# City of Bellevue

**RE: Pinnacle Bellevue North  
Project #: 21-103195-LD; 21-103192-LP  
Revision Request #11**

The Development Review Committee (DRC) has reviewed the plans submitted on March 26, 2025 for the Administrative Design Review, file number 21-103195-LD and Master Development Plan, file number 21-103192-LP. Below are additional comments and revision requests from the City's review team. **Please note that additional information may be requested as a result of our review of your resubmittal.**

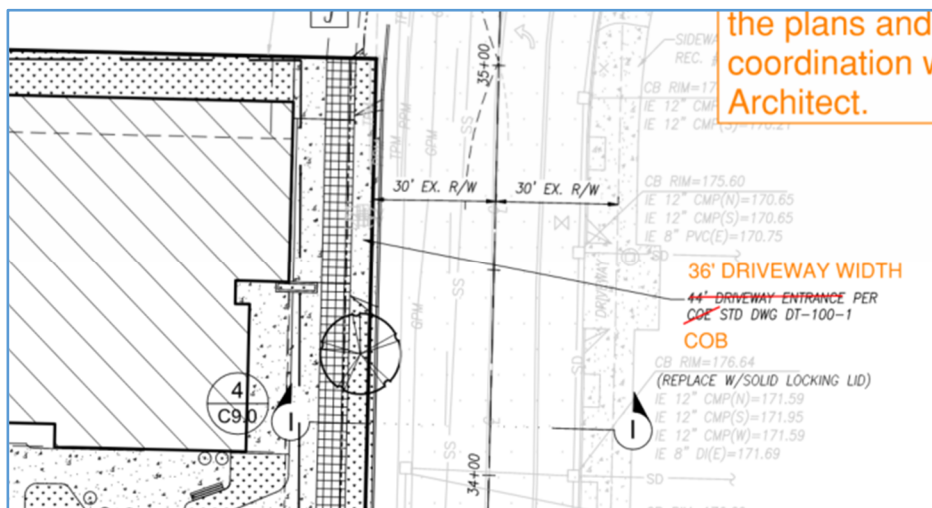
6. The FAR Bonus Amenity Table requires additional revisions due to the miscalculation of the FAR for the A-1 Land Use District which affects the distribution of your Floor Areas for market rate and affordable housing units. See attached Marked Up Amenity Plan Tables.
7. **Repeat Comment:** Civil Plans must be coordinated with the Architectural and Landscape Site Plans. When you show one dimension in the Civil Plans, you must ensure there are no conflicting information on the Landscape Plans or Architectural Plans. We continue to see confusing numbers on your plans. Example, the driveway width for garage entrance at 102<sup>nd</sup> Ave. NE.

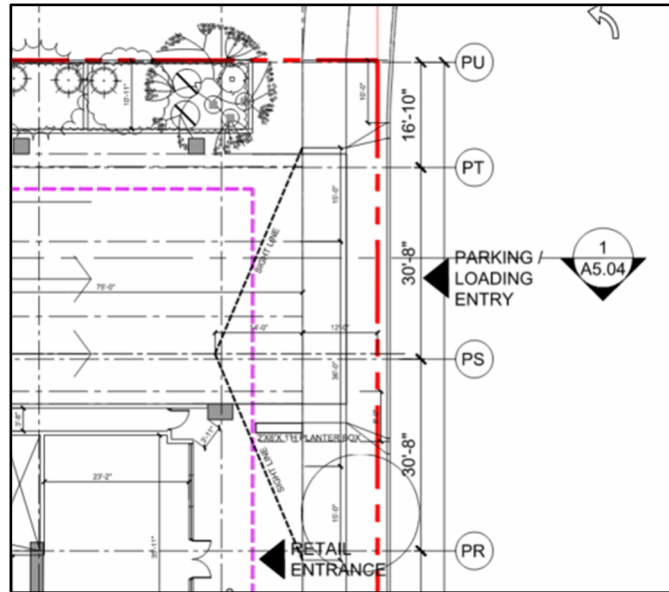
Driveway width shown as 44' on Civil Plan sheet SPA1, Site Plan A

Driveway width shown as 30'-8" on Architectural Plan Sheet A1.11

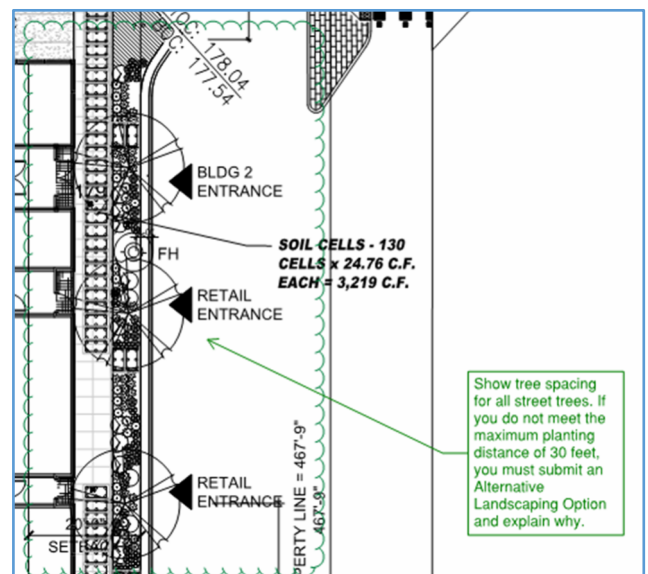
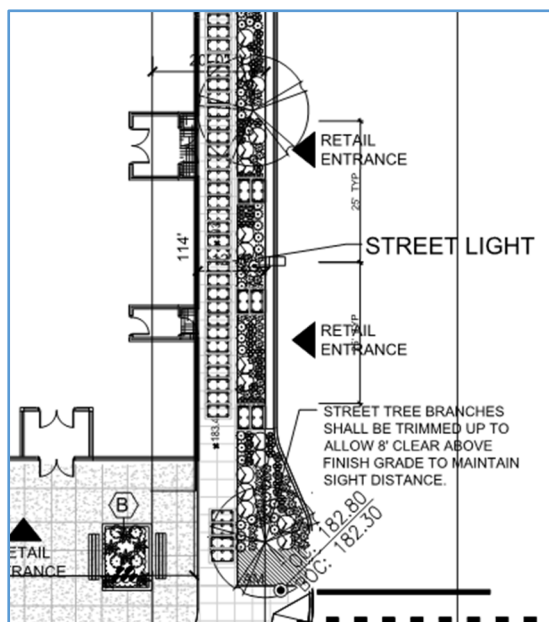
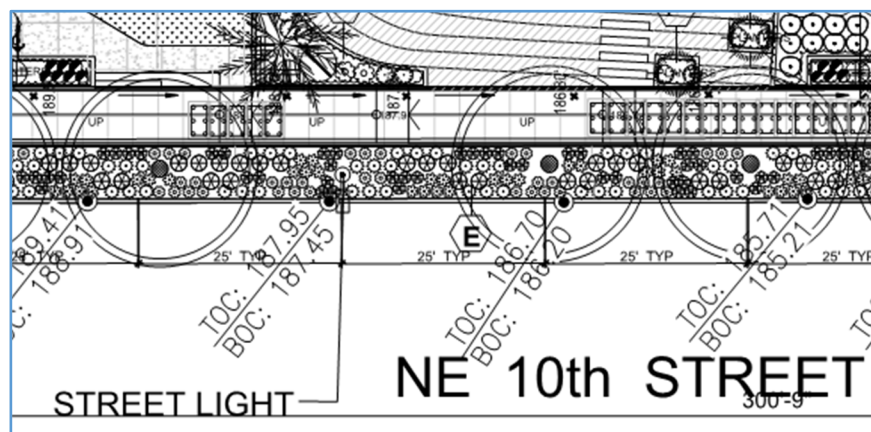
**11. New Departure Request – Garage Exhausts:** A departure request must be submitted for locating garage exhausts next to sidewalks OR design garage exhausts as towers with vents directed away from pedestrian areas. Per discussion with Kandice, garage exhausts at 102nd Ave NE is flushed to the sidewalk, located next to the main doors of the drugstore entrance. Garage exhausts next to the sidewalk of Building 6 and the internal roadway is 8 inches above the finished grade. Both these 2 locations do not meet LUC 20.25A.130.D.2.

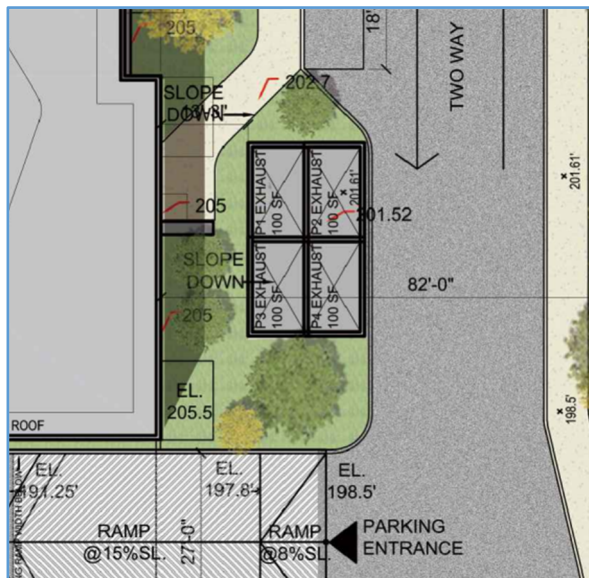
**25.** Bike parking. The proposed number of bike parking, as shown on the Amenity Plan and Chart are acceptable. However, there is missing or inconsistent information regarding the following:

- a. **Repeat Comment:** Given the size of your development, bike storage should be distributed among the 6 residential buildings and not concentrated in one location. Covered bike storage should be accessible from all residential tower lobbies and the employees of the tenant spaces. The bike storage area appears to be only accessible from the Outdoor Plaza on 102<sup>nd</sup> Ave. NE. Explain how the residents and employees will safely access the covered bike storage area from each of the 6 building lobbies.
- b. Access to covered bike parking/storage rooms must be intuitive and safe; i.e. from the Outdoor Plazas, residential lobbies or direct access from the sidewalks.

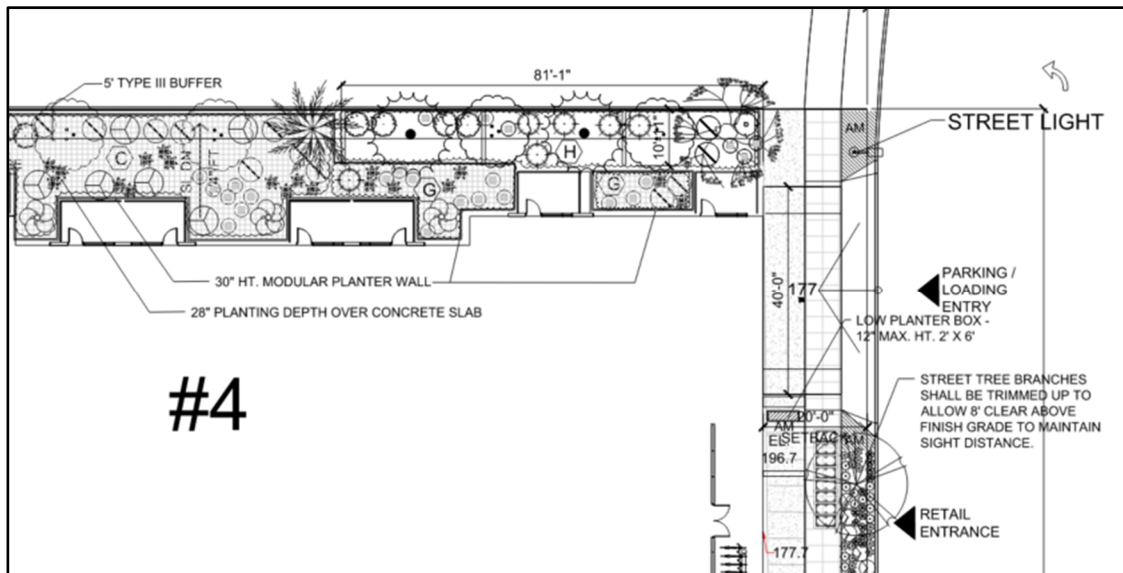
**32. Courtesy Notice:** Your Outdoor Plaza seating calculations show that one plaza exceeds the minimum required seating of 1 LF/30 S.F. of plaza area, as follows:

Outdoor Plaza 1 (north): 8051 S.F.  
 $8051/30 = 268.3$  linear feet (required)  
Proposed seating length: 175 L.F.

Outdoor Plaza 2 (south): 13,605 S.F.  
 $13,605/30 = 453.5$  linear feet (required)  
Proposed seating length: 556 L.F.

Total required linear feet of seating:  $21,656 \text{ S.F.}/30 = 721.87 \text{ LF}$   
Total proposed linear feet of seating: 731 L.F., which is greater than the minimum required.

While you meet the minimum requirement for the MDP, if you decided to phase the project in the future, you will need to revise the Outdoor Plaza design to comply with the seating requirements if both plazas are not built at the same time.

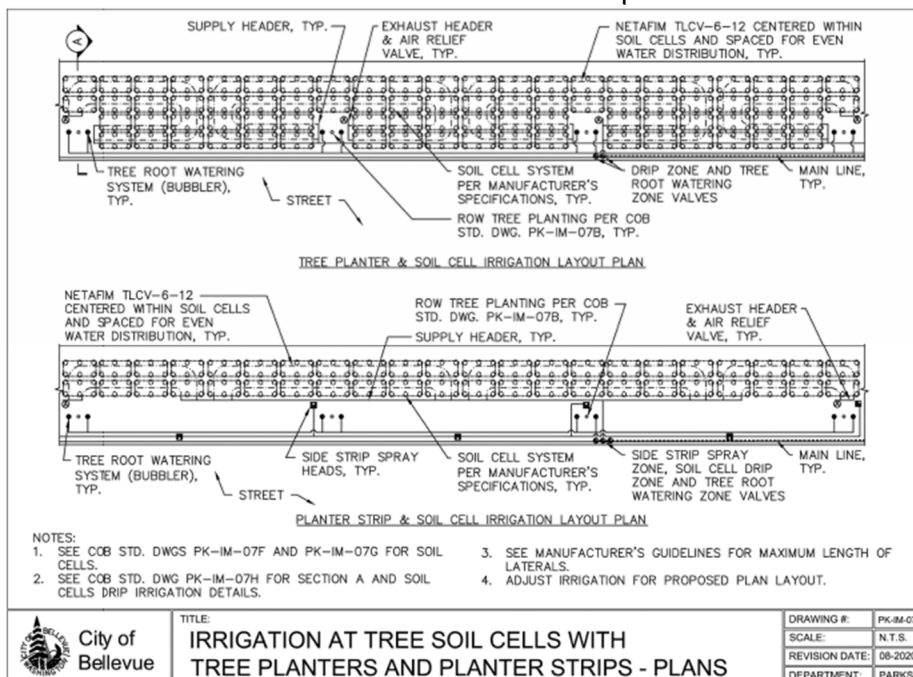
- Tree spacing is not consistent between the landscape sheets. LA 102 shows trees along 102<sup>nd</sup> regularly spaced as they should be at 30', but sheets LA100 and LA 101 show the 2<sup>nd</sup> tree south of the mid-block crossing to be shifted about 4' north of where it

should be. If there is a conflict that requires this shift, please explain. Tree spacing needs to be consistent between all sheets.
